Petition No. 734

Traffic Engineering Division - DPW  
(Utility or City Department)

PETITION NO. 734  
 E&B BREWERY LOFTS  
 1551 WINDER ST.  
 DETROIT, MI 48207  
 JAMES J. PELLERITO  
 PHONE NO. (313) 782-4993

REQUEST ENCROACHMENT  
 TO INSTALL UNIVERSALLY ACCESSIBLE  
 RAMP/STAIRS AT 1551 WINDER STREET.

DRWG. NO. X 734

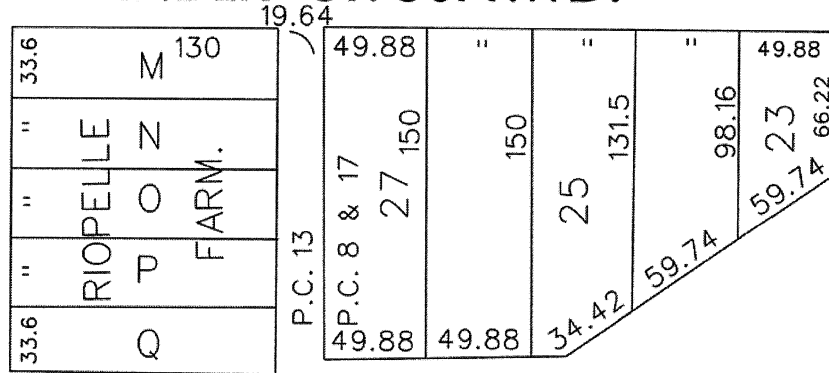
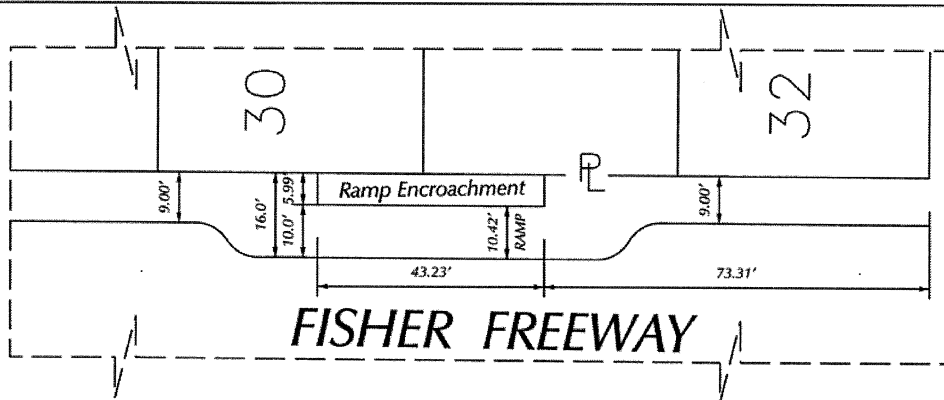
- ( ) Not Involved.
- ( ) Involved; but asking you to hold action on this petition until further notice.
- ( ) Involved; the nature of our services, and the estimated costs of removing and/or rerouting such services are:
- (X) Involved; **have objection** to request for encroachment to install universally accessible ramp/stairs at 1551 Winder Street as shown on drawing no. X 734 dated 03/12/2019 because sidewalk is not meeting the minimum required width. A minimum width of 6 feet clear sidewalk is required after the proposed encroachment.
